Village of Chenequa Plan Commission
Monday, February 12, 2024 at 6:00 p.m.
31275 W. County Road K, Chenequa, WI 53029

STAFF REVIEW

Subject: Site Plan Review

Project Description: Proposed Remodel/Addition to a Legal-Nonconforming Structure

A-901

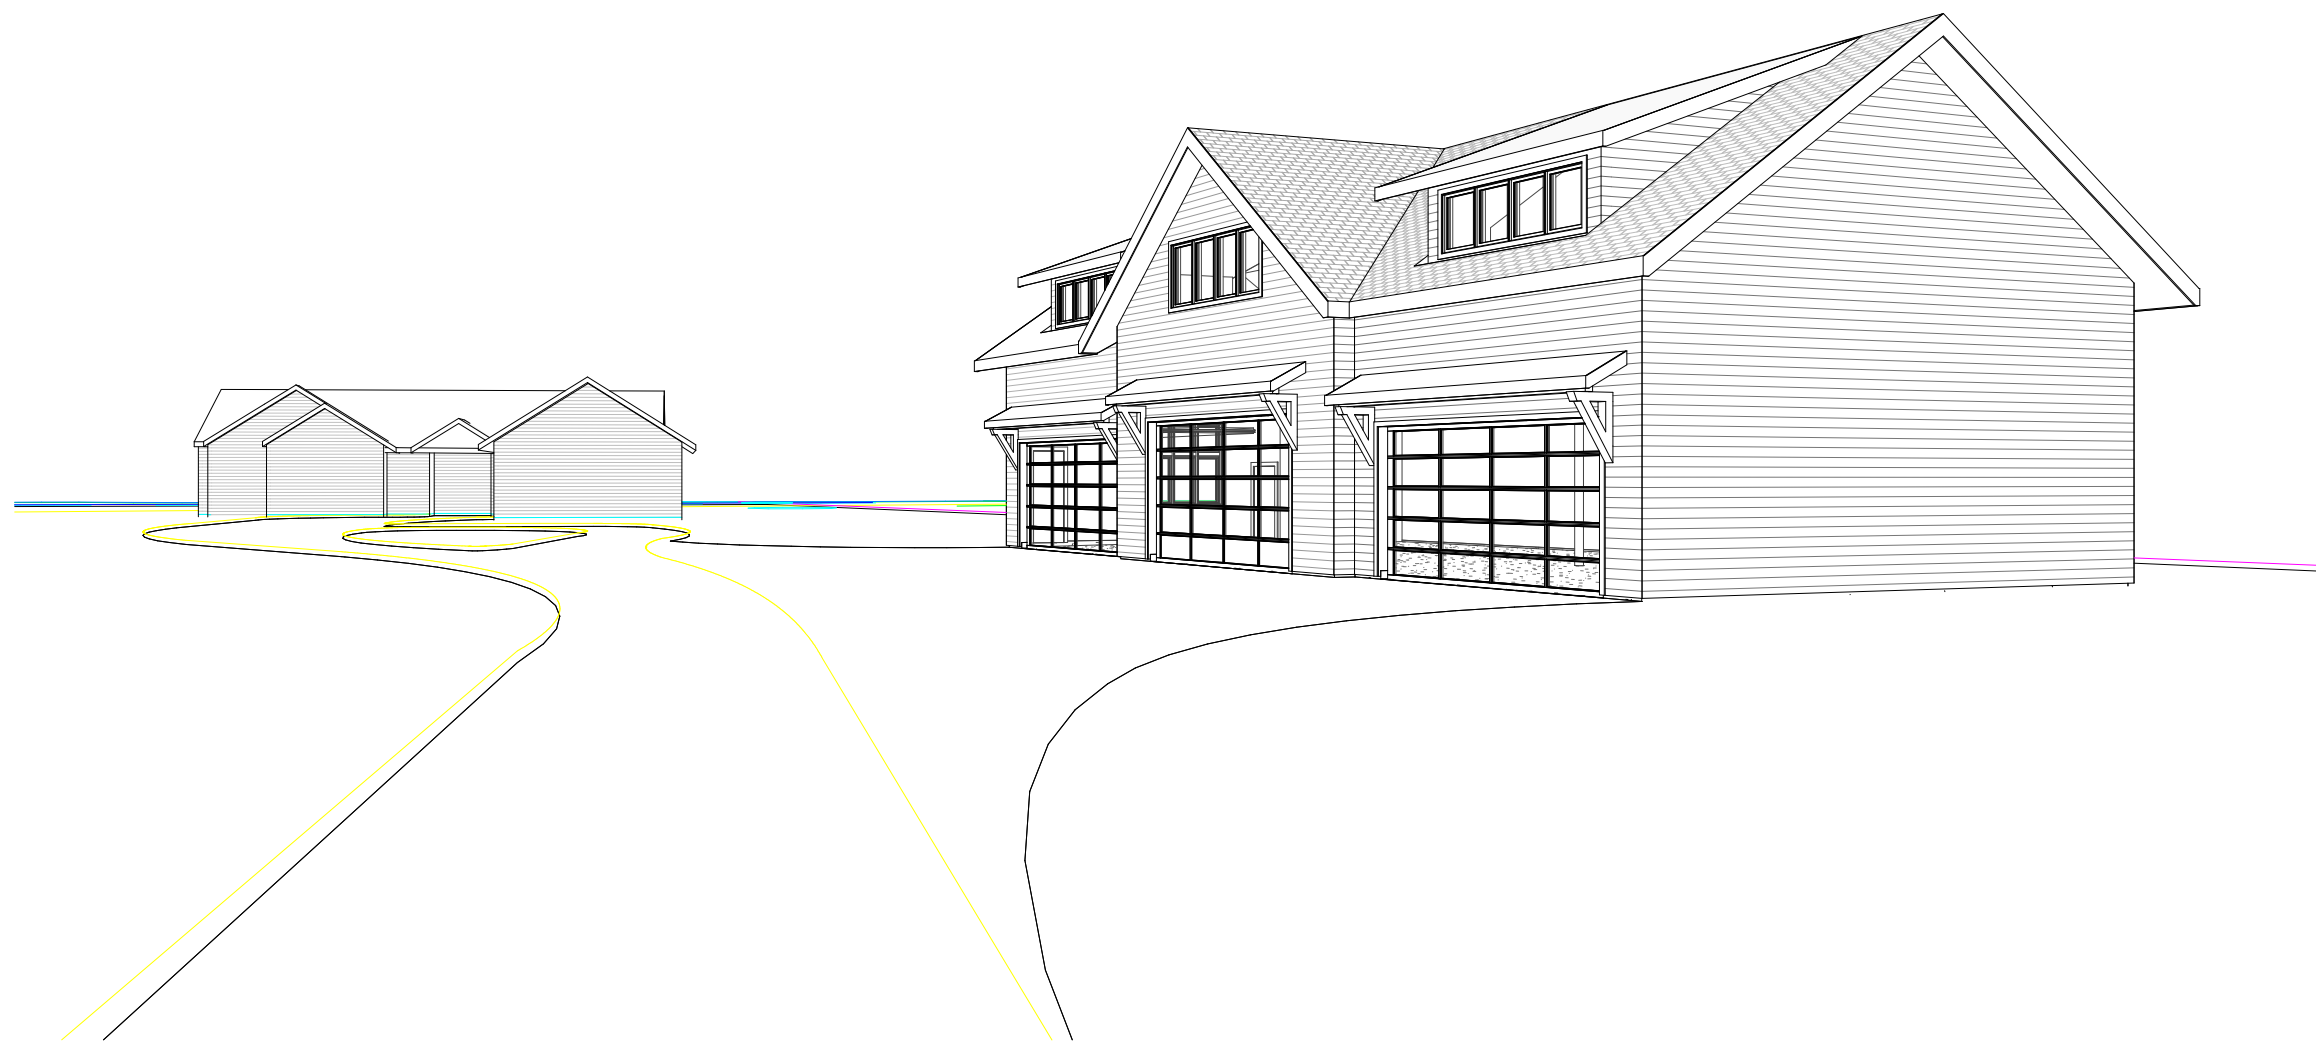
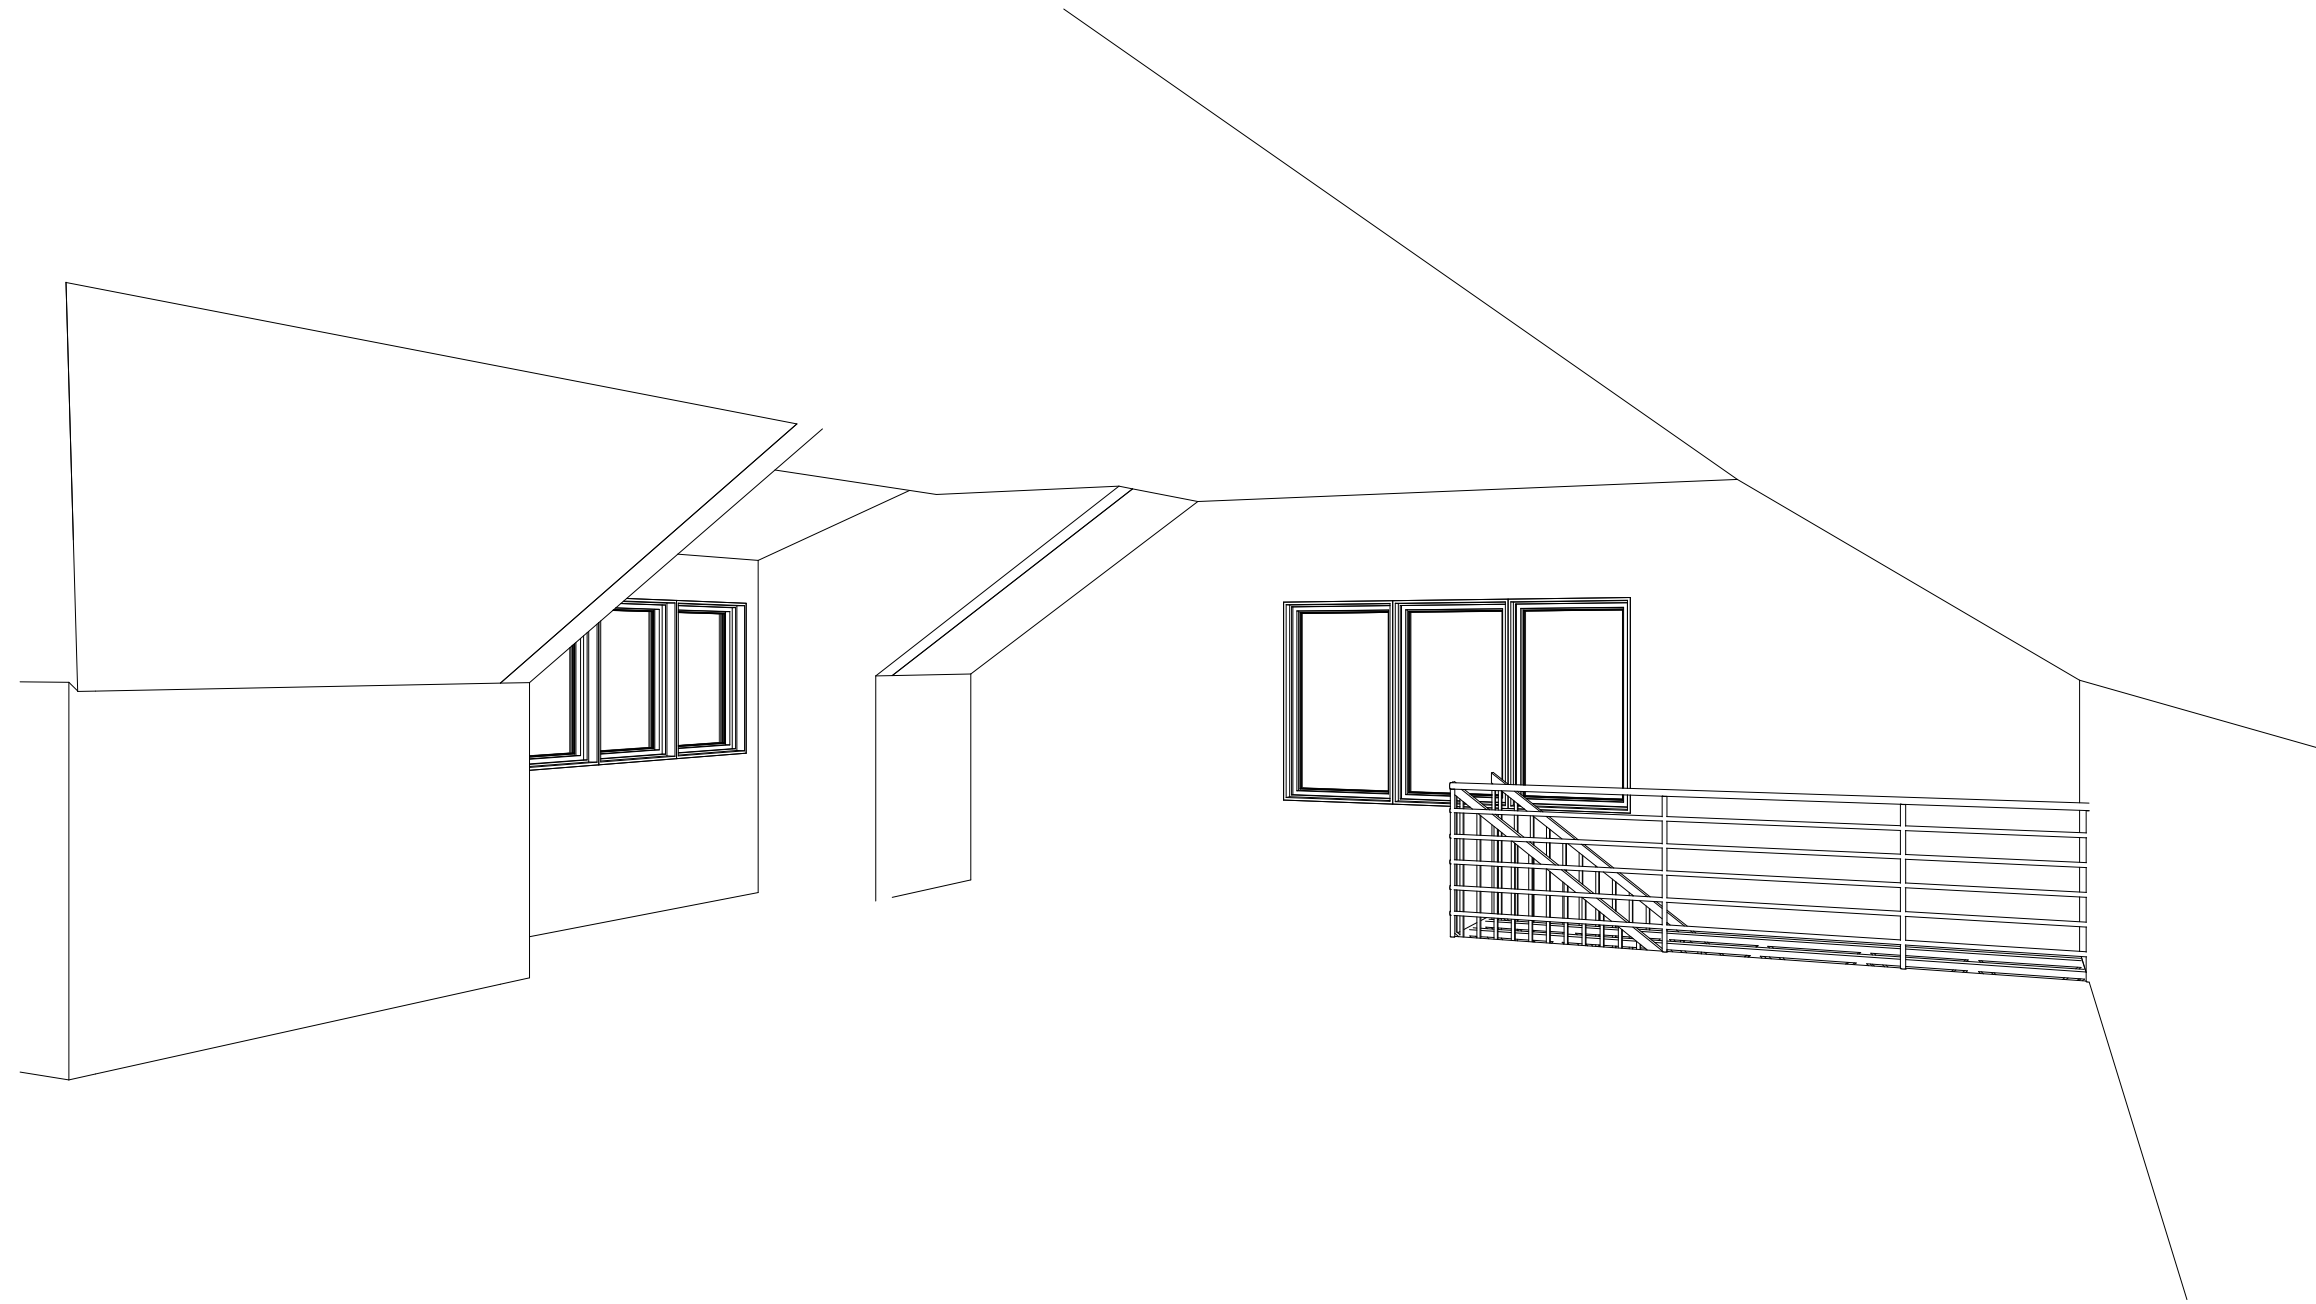
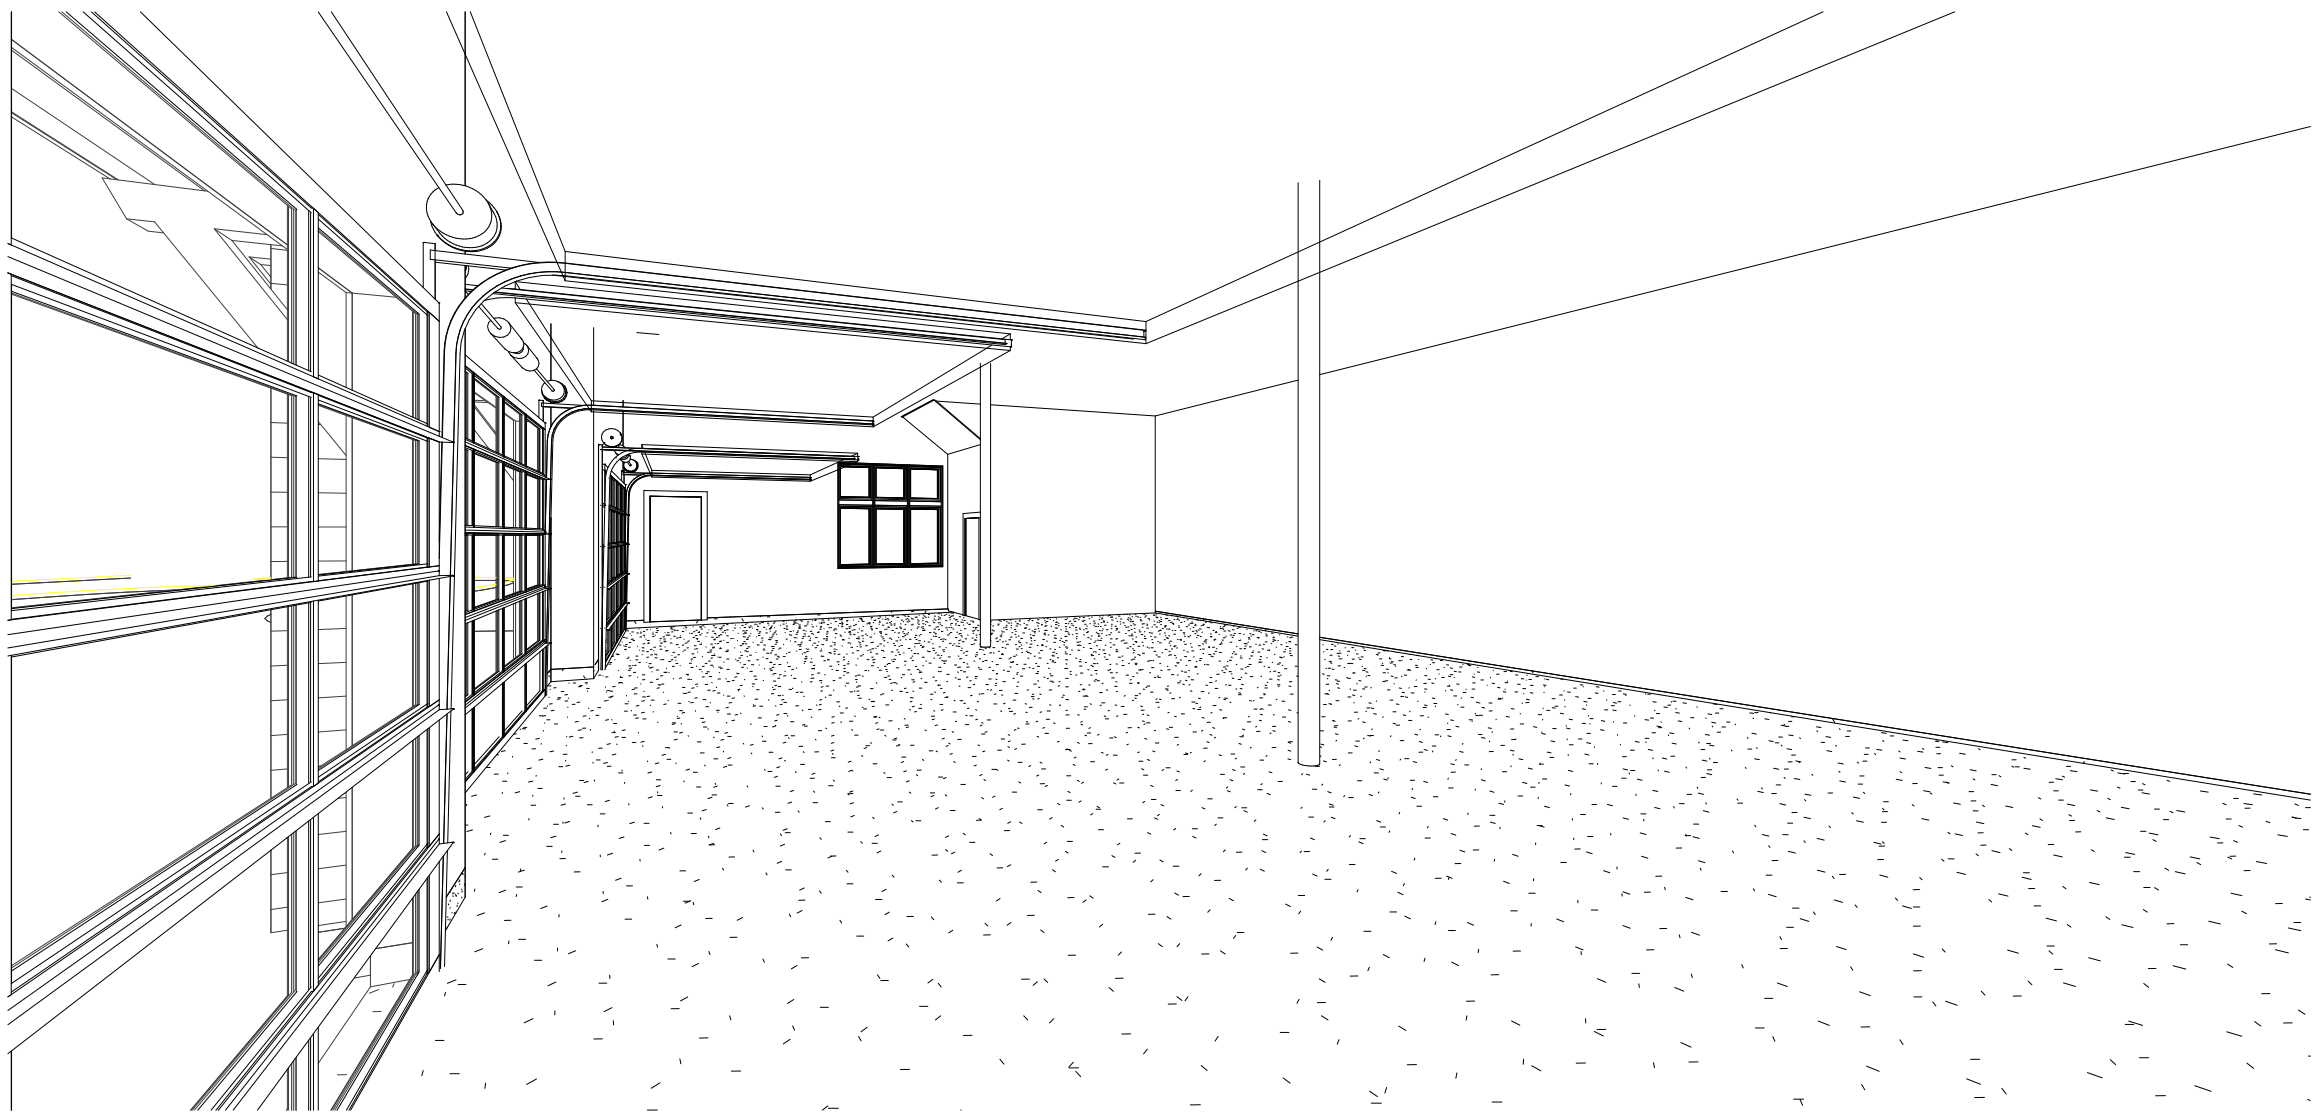
6. This structure is proposed to be sheathed with green lap siding to match the existing dwelling. (See color rendering)
7. An exterior light option has not been submitted
8. A building permit is required from the Building Inspector prior to start of construction.
